MITIGATION PLAN

ALEXANDER FARM MITIGATION SITE

SUBJECT: Alexander Farm Mitigation Site - NCIRT Comments during 30-day Mitigation Plan Review

RE: Alexander Farm Mitigation Site
Response to NCIRT Mitigation Plan Review Comments
USACE Action ID No. SAW-2018-00451

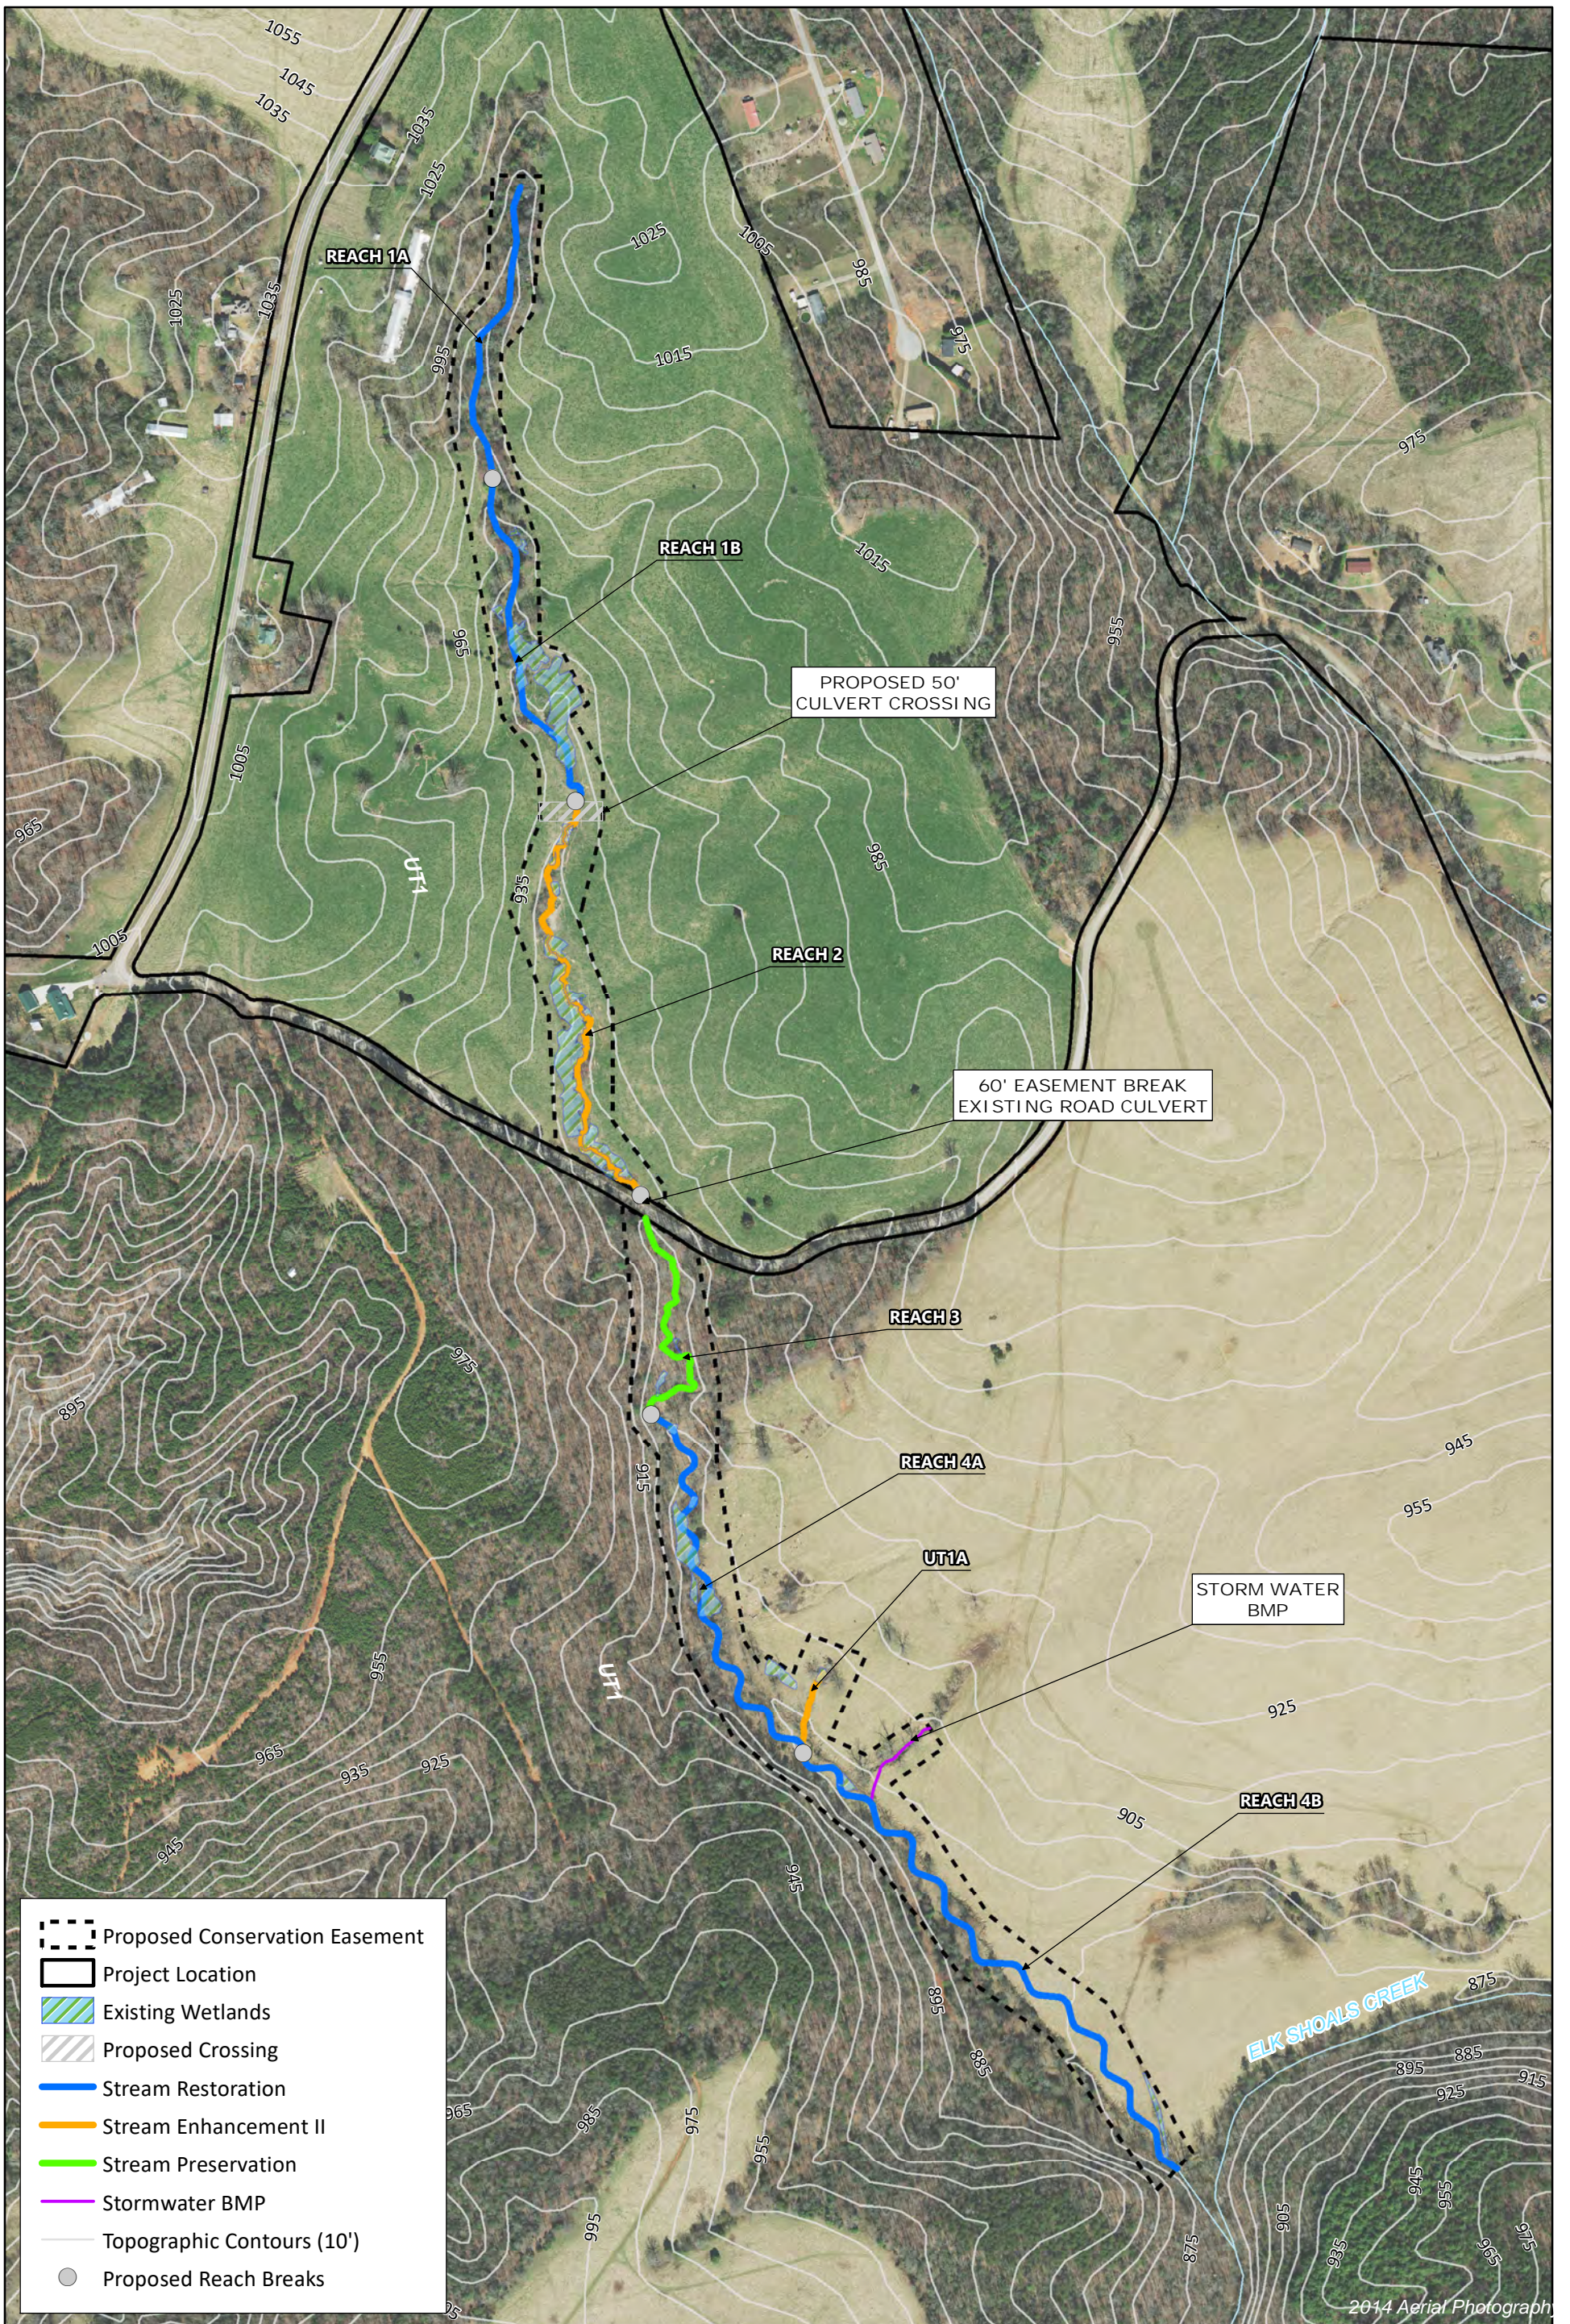
stream channel through Priority 1 restoration? Additionally, there appear to be several more wetlands shown on the JD Map that are not captured on Figure 9.

3. *Section 5.3 and Table 7: There are several reaches of stream restoration proposed (1B, 4A, 4B) that will impact existing wetlands. Please describe how you will ensure that no functional loss/loss of waters occurs. Specifically, will the 0.17 acres of permanent impacts be recuperated adjacent to the newly raised stream channel through Priority 1 restoration? Additionally, there appear to be several more wetlands shown on the JD Map that are not captured on Figure 9.*

- a. *It would be beneficial to add some coarse woody debris to the depressional areas and throughout the adjacent wetlands for habitat, and to help store sediment increase water storage/infiltration and absorb water energy during overbank events.*

Wildlands Response: The existing wetlands that will be impacted by stream restoration activities are currently impacted by cattle grazing and trampling. Priority 1 restoration will allow for the stream to be raised, which will raise the water table helping to restore or enhance the adjacent wetlands. Wildlands will take precautionary measures to protect the existing wetlands, including the installation of safety fence to establish grading limits adjacent to the wetlands. Wildlands will use the project's proposed stream flow pressure transducers or crest gauge to show that stream flooding is enhancing surface hydrology on the floodplain adjacent to project reaches. Figure 10 shows all the delineated wetlands that are shown on the JD Figure. The symbology was changed to make it more visible on the figure. A symbol for large woody debris was added to the plans and placed within the proposed vernal pools.

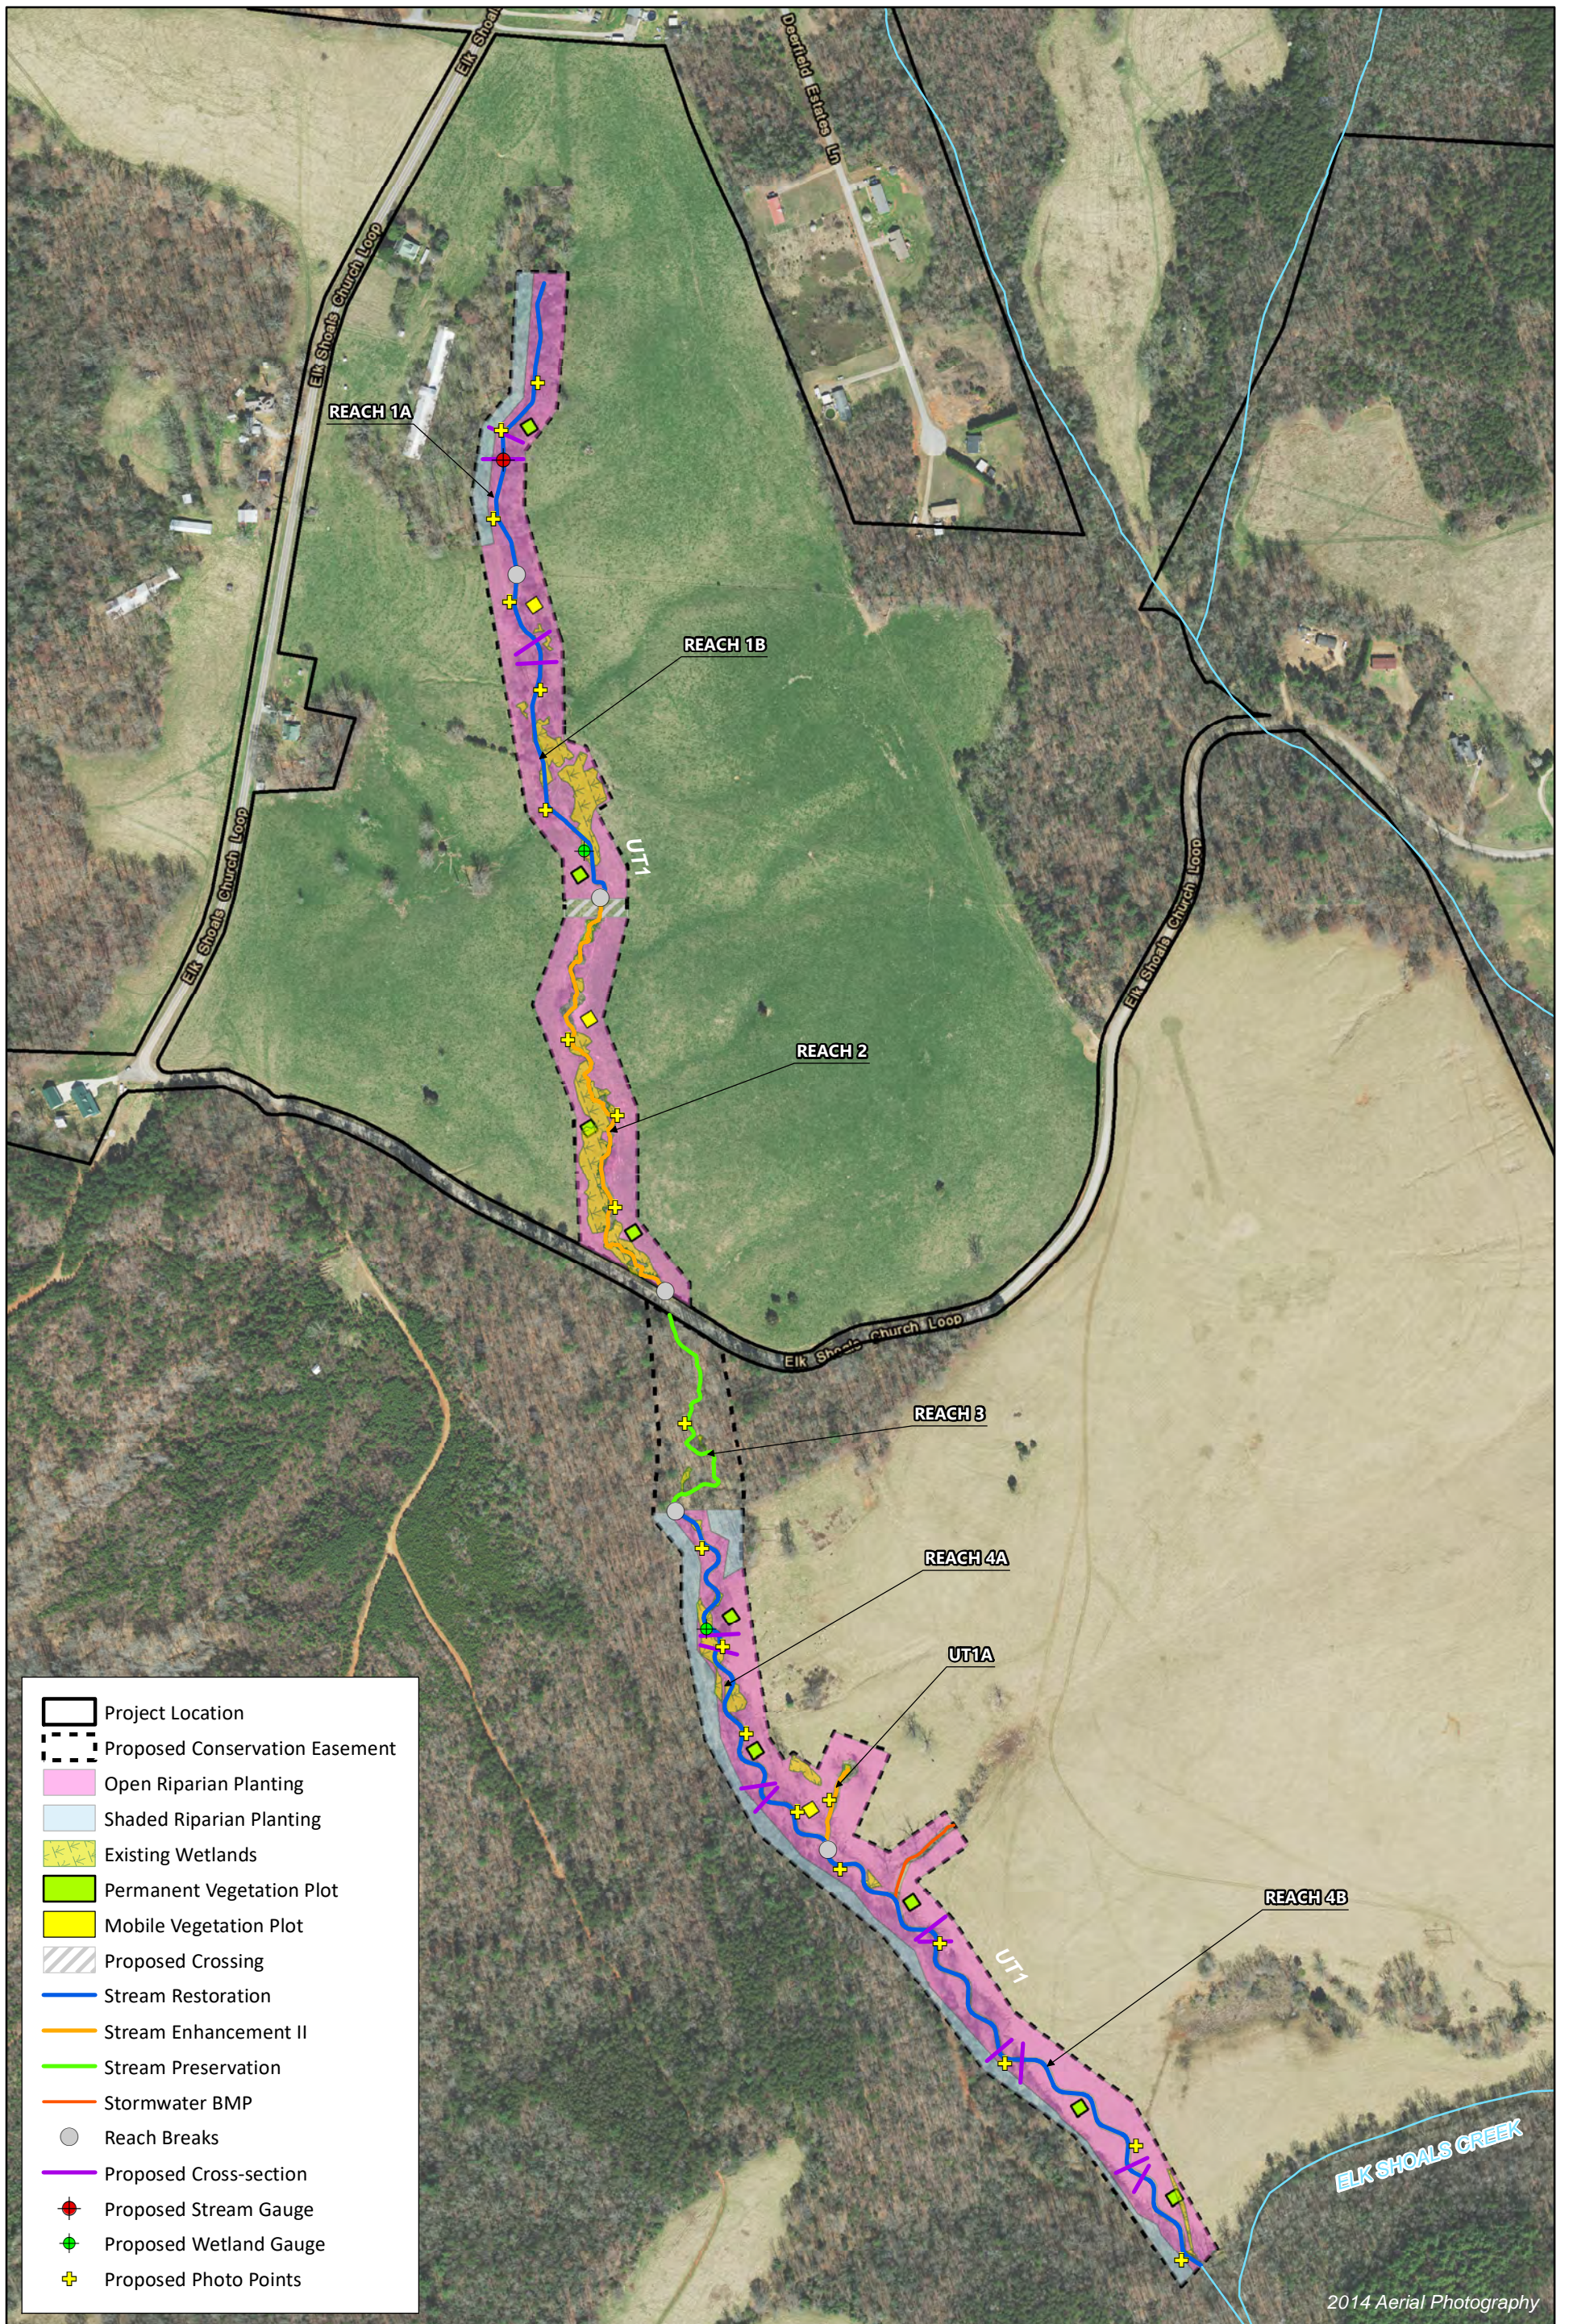
- a. The IRT also noted that wetland gauges should be installed to collect pre-data. Was this conducted? If so please explain and note on the monitoring map (figure 10).

- b. Stream lengths and credit calculations should be revised based on the above.
6. It would be helpful to depict photo points/digital image stations on Figures 10. If the fixed cross-section locations are to be used, please describe that in the text.

- a. *The IRT also noted that wetland gauges should be installed to collect pre-data. Was this conducted? If so please explain and note on the monitoring map (Figure 10).*

Wildlands Response: The comment during the IRT site walk was made assuming wetland credits would be claimed. Since the decision was made not to pursue wetland credits, pre-construction gage data was not required or collected.

Wildlands Response: Figure 10 has been updated to show approximate locations of fixed photo points for post-construction monitoring. These locations may be adjusted in the baseline monitoring report.
